# MultiCare Good Samaritan Hospital Kitchen

**07.21.2025**
**PW PROJECT #162433.000**

# PHASE 1 PERMIT CORRECTIONS

**FIRE RESISTANCE DETAILS AND DIAGRAMS**

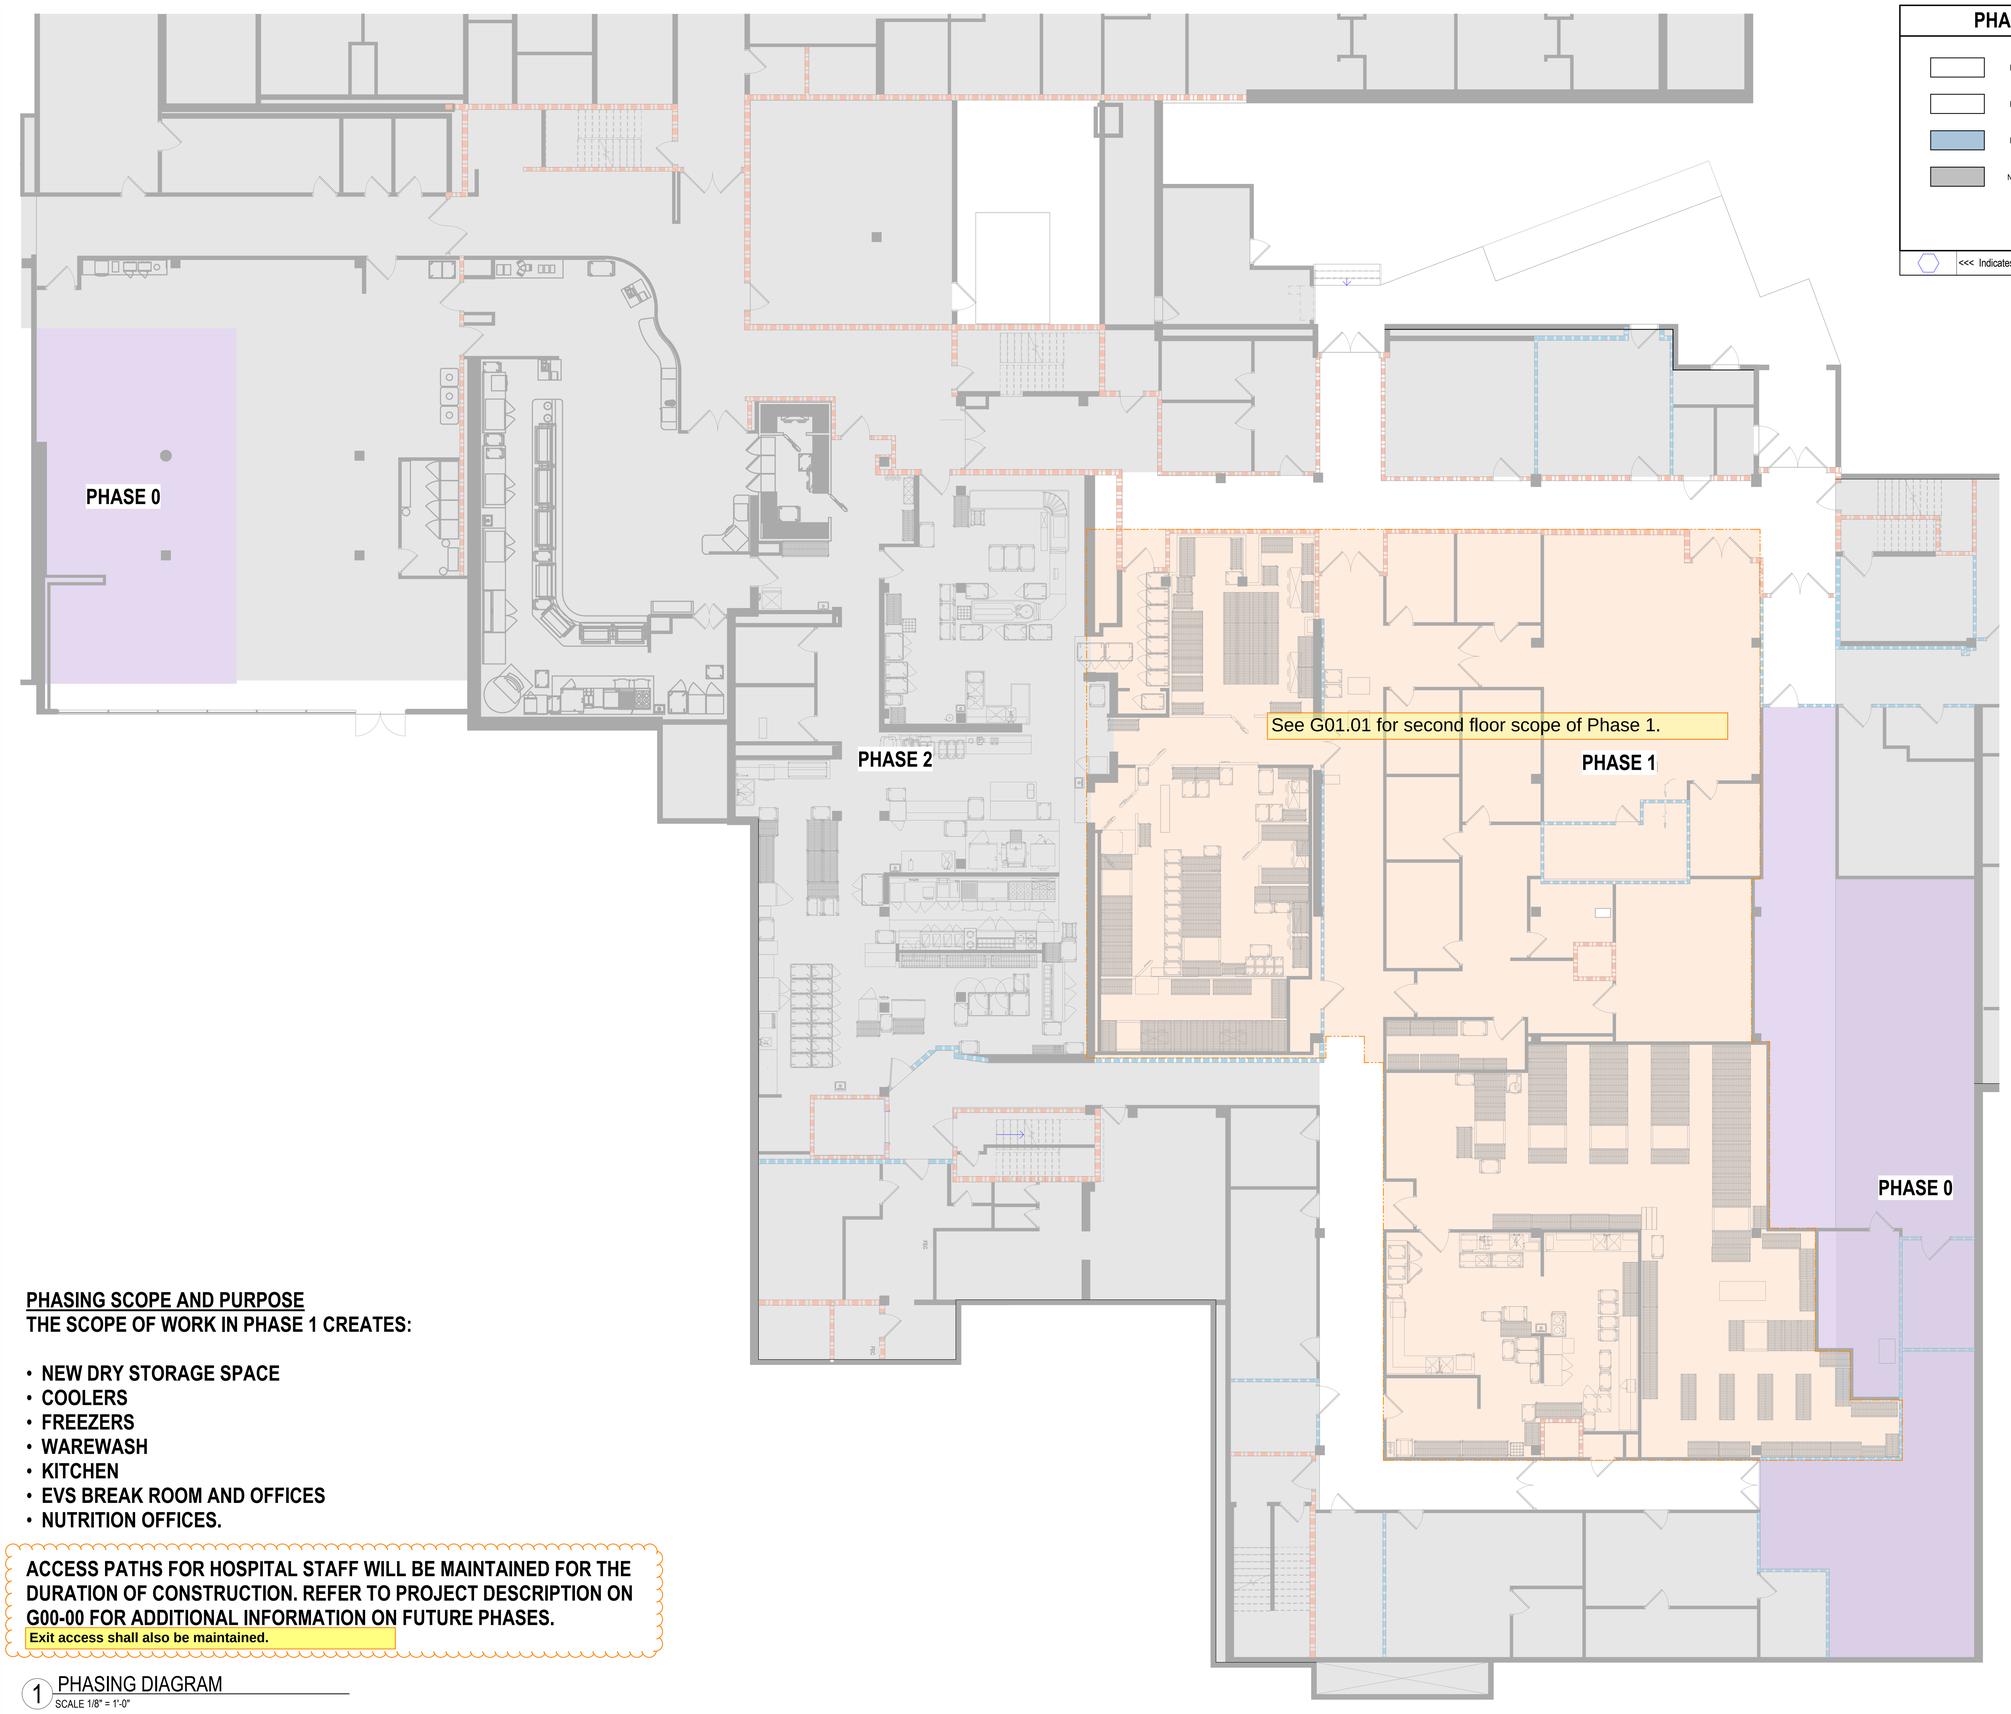
Deferred Submittal Required
Details for fire resistant penetration, including electrical, plumbing, mechanical, etc.
Please provide penetration type and listed assembly details.
G05.01

1 UNDERGROUND - PLUMBING - AREA B SOUTH
SCALE: 1/4" = 1'-0"

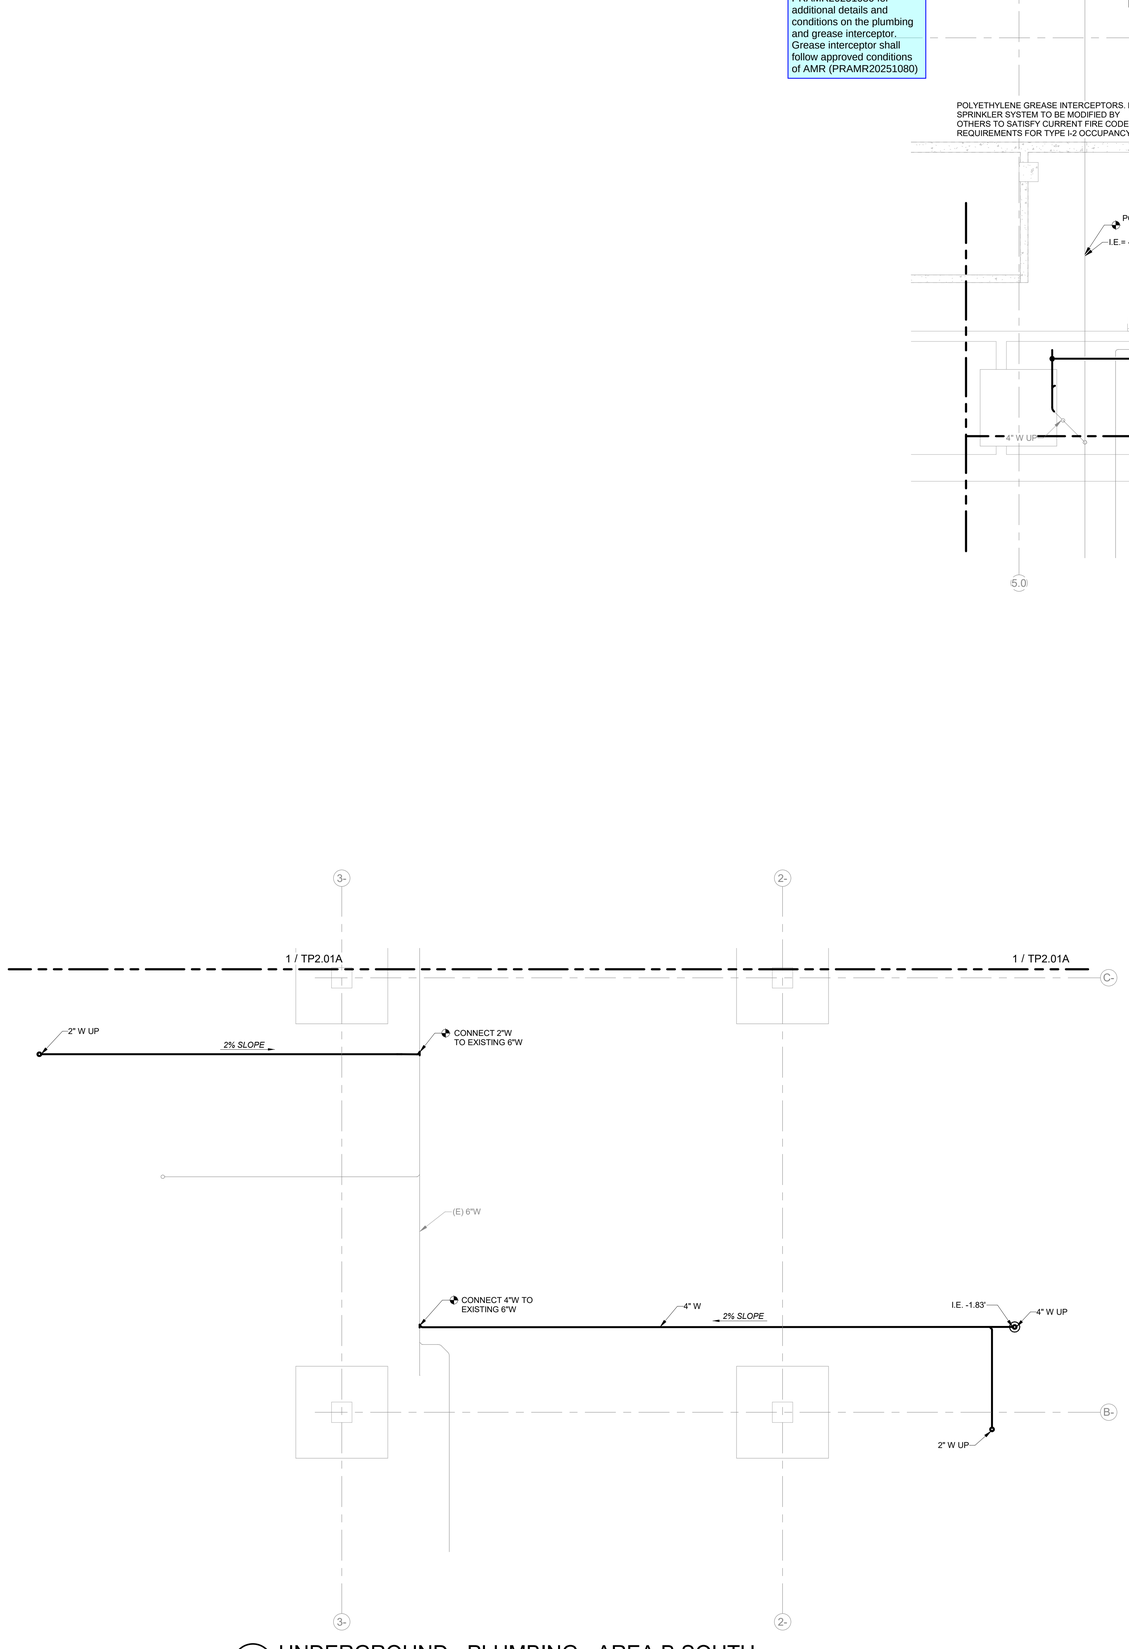
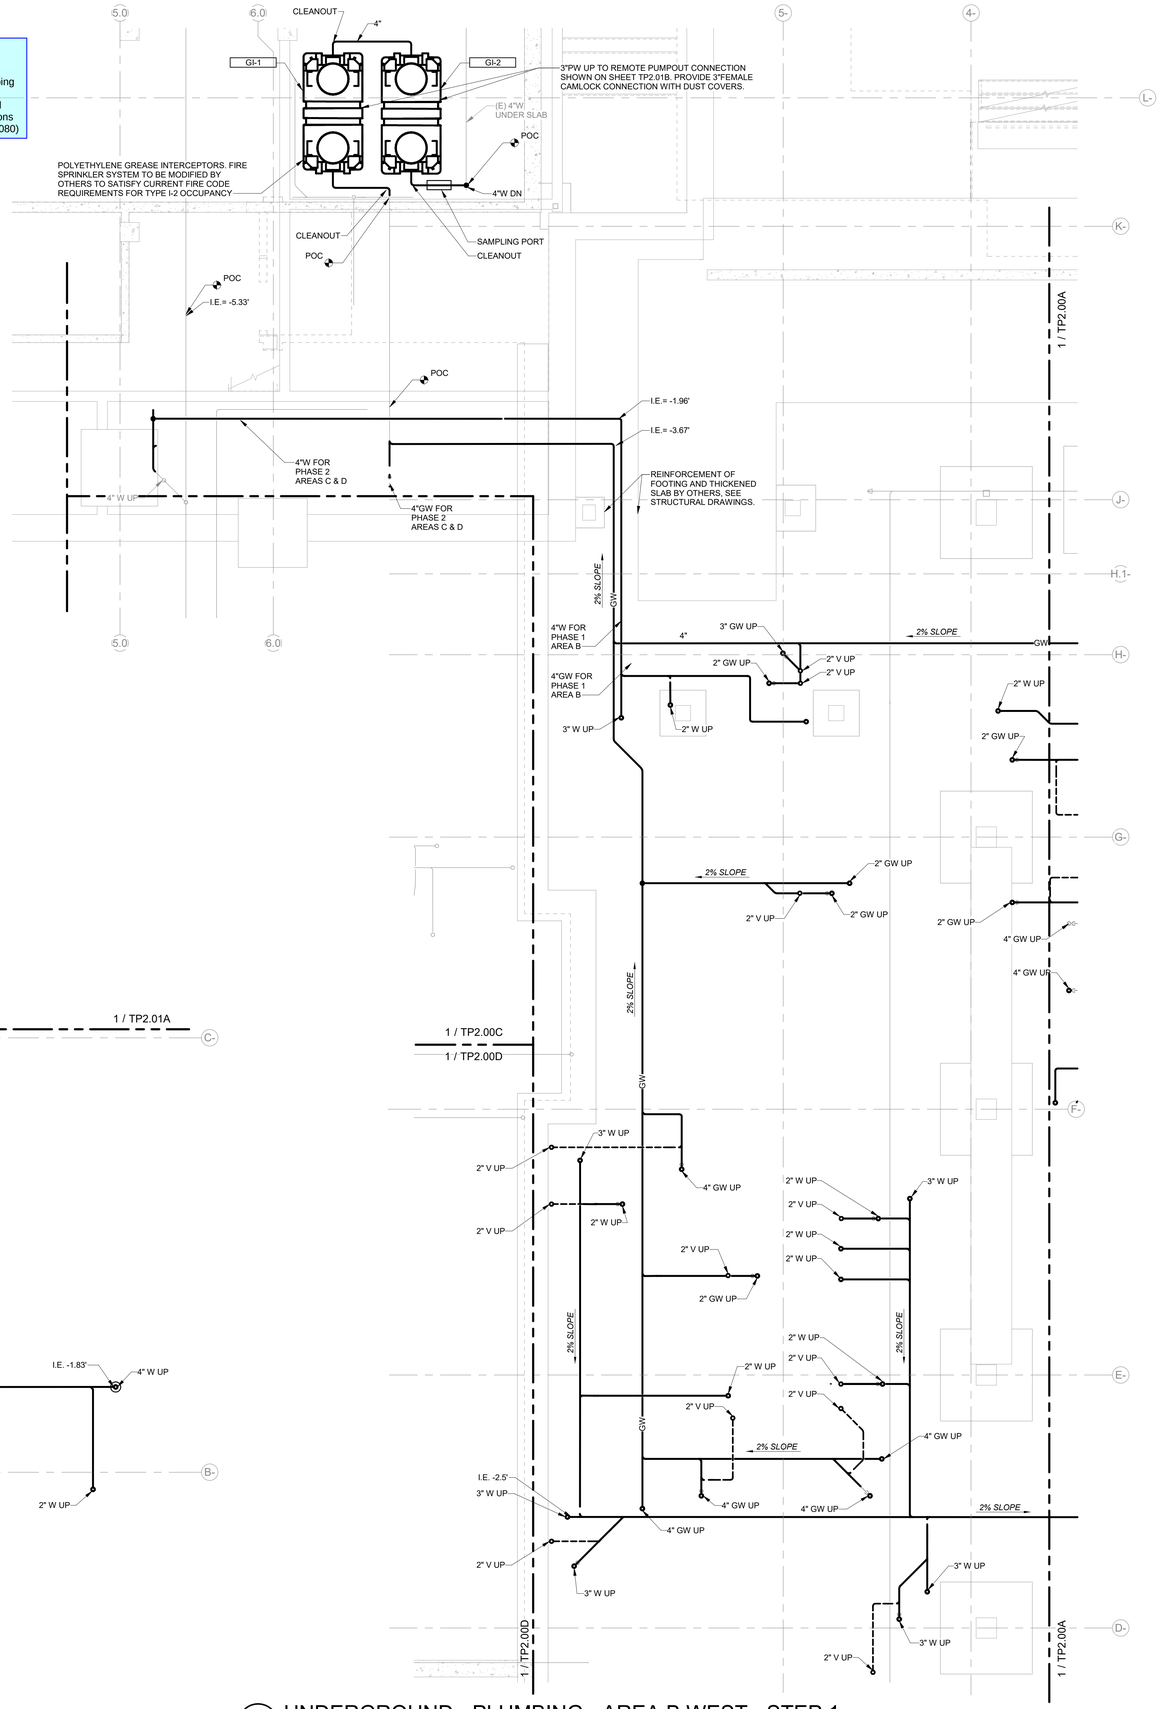
Refer to approved PRAMR20251080 for additional details and conditions on the plumbing and grease interceptor. Grease interceptor shall follow approved conditions of AMR (PRAMR20251080)
